Work Order ID 140363

Item Name: Quick Release Heli-Utility-Basket™ Long, HD Lid, Spacepod™/Squirrel Cheek Comp.

DART SERVICE INSTRUCTION

TO AMEND INSTALLATION INSTRUCTIONS D350-607-3 Rev.D,
INSTALLATION INSTRUCTIONS D350-607-4 Rev. C AND
INSTRUCTIONS FOR CONTINUED AIRWORTHINESS ICA-D350-607 REV. 6
REF TCCA STC: SH94-14
REF FAA STC: SR00213NY
REF EASA STC: EASA.10016996
REF BRAZILIAN STC: 2007S03-03/-04/-05/-06

FIGURE 1: INSTALLATION OF D4775-041 FWD STRUT

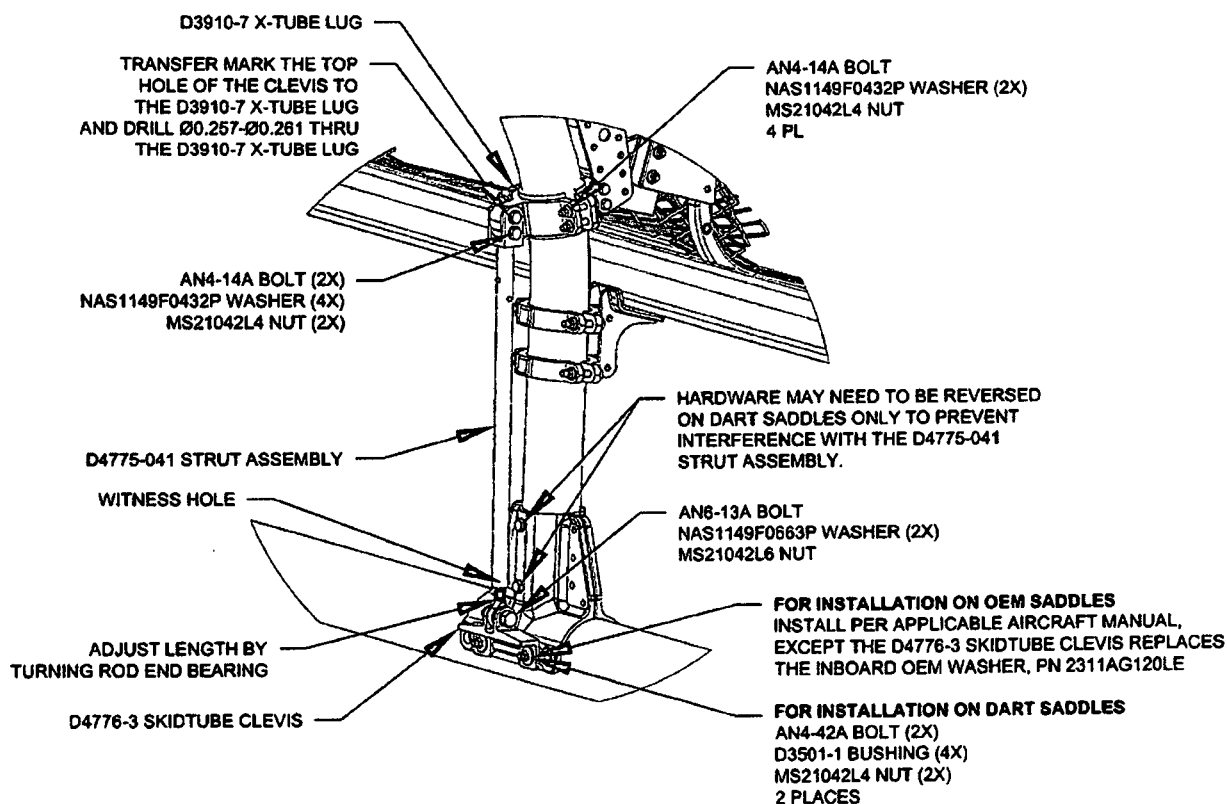
- 3.1 Substitute the Forward Lower D3910-5 X-Tube Lug with the D3910-7 X-Tube Lug as shown in Figure 1.
- 3.2 Install the forward D4775-041 Strut Assembly. Transfer mark from the upper hole on the clevis of the D4775-041 Strut Assembly to the D3910-7 X-tube Lug and drill thru the lug $\varnothing 0.257$ - $\varnothing 0.261$ as shown in Figure 1. Touch up chemical conversion coating per MIL-DTL-5541. Check the witness holes located at the bottom end of the D4775-041 Strut Assemblies to ensure that the thread from the rod end extends past the witness hole.
Torque MS21042L4/-4 nuts to 50-70 in-lbs (5.7-7.9 N-m). Torque MS21042L6/-6 nuts to 160-190 in-lbs (18.1-21.5 N-m).
- 3.3 Complete the installation in accordance with Installation Instructions D350-607-3 Rev. D or D350-607-4 Rev. C.
